**Technical Bulletin**  
206/407AC-13-1, Rev. 0  
01/25/2013

Owners/Operators of Bell Model 206 Series or 407 helicopters equipped with Paravion Technology, Inc. Air Conditioner Installation Kits P/N 206AC-110-(X), 206AC-111-(X), 407AC-110-(X)

Compressor Service Fitting Replacement

FIGURE 1

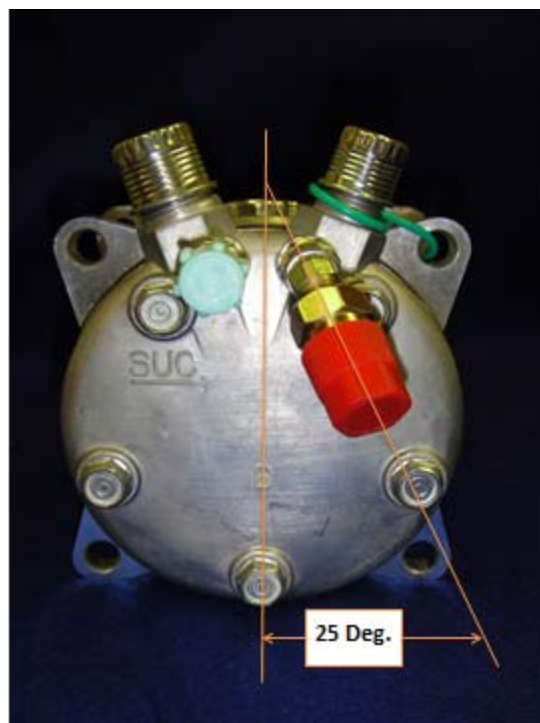
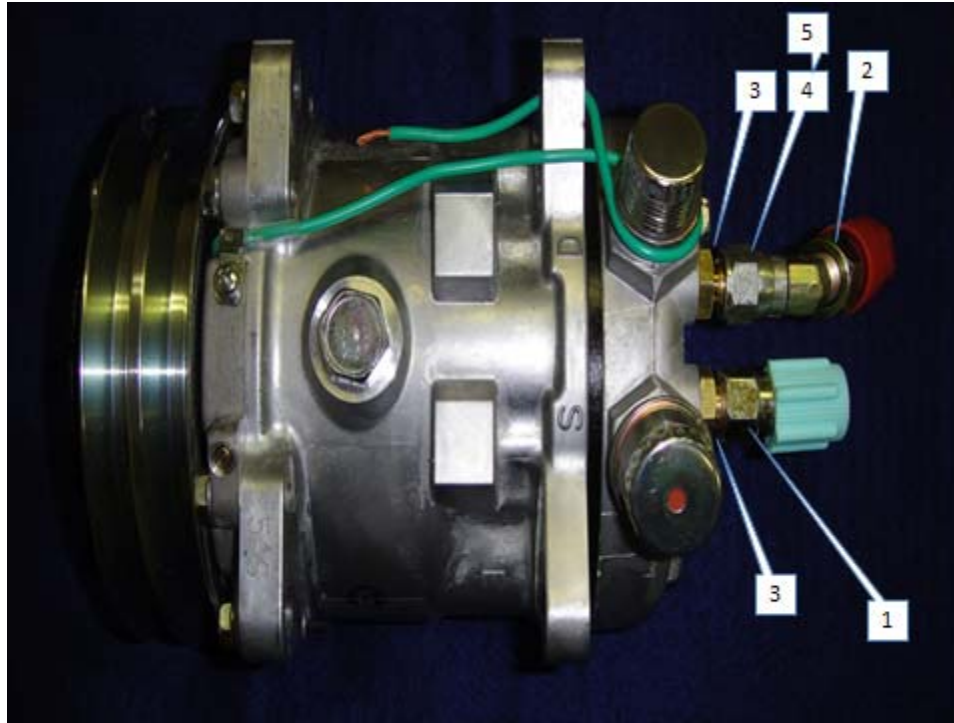
- D. With figure 1 of this document as a guide, install new fittings. Maintain the 25 deg. angle shown to facilitate servicing. Torque all fittings per ICA torque table recommendations.
